# Agenda

## Landmarks Preservation Commission Community & Economic Development Department

Date: September 22, 2010  
Location: 728 St. Helens, Tacoma Municipal Bldg North, Room 16  
Time: 5:00 p.m.

LPC 39/10

DR 3.4

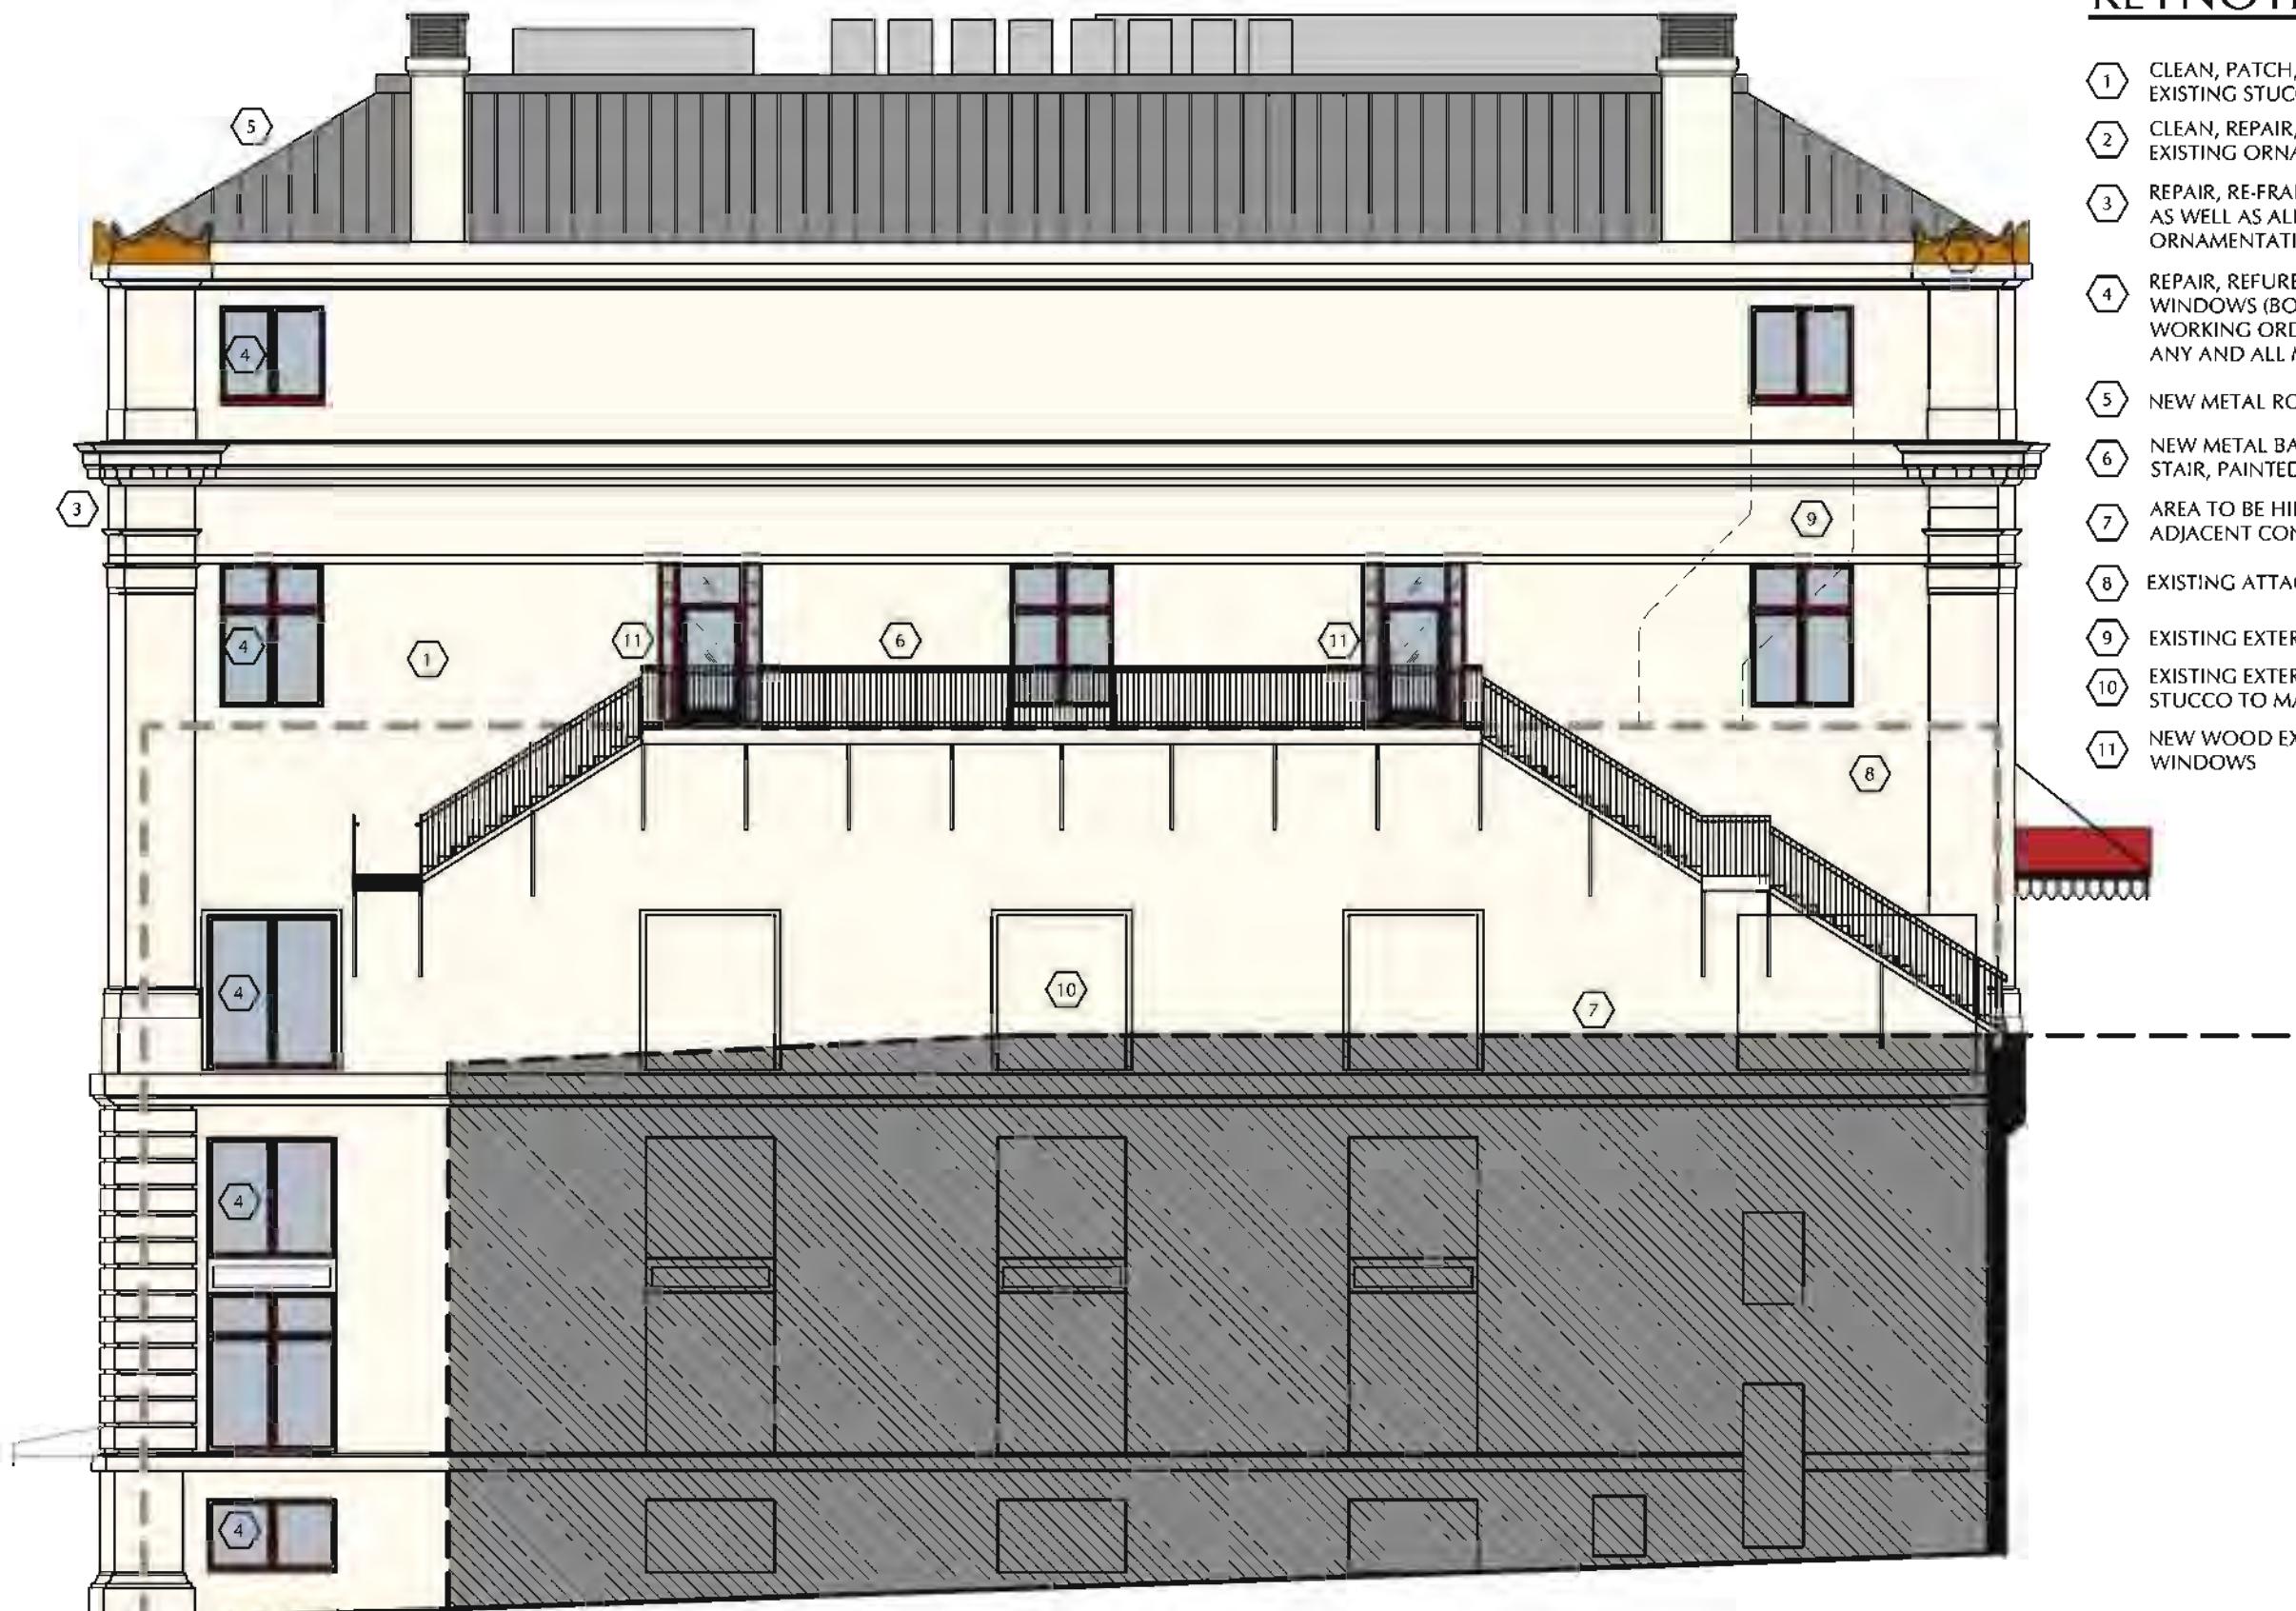
3. Balcony elements will be repaired, refurbished, and repainted, including refinishing and extending six inches in height on sixth floor railings. (DR 7.5) New iron safety railings will be installed at all balconies. Install new metal balcony and exterior exit stair, painted black on north elevation as shown on plan set (DR 3.4).
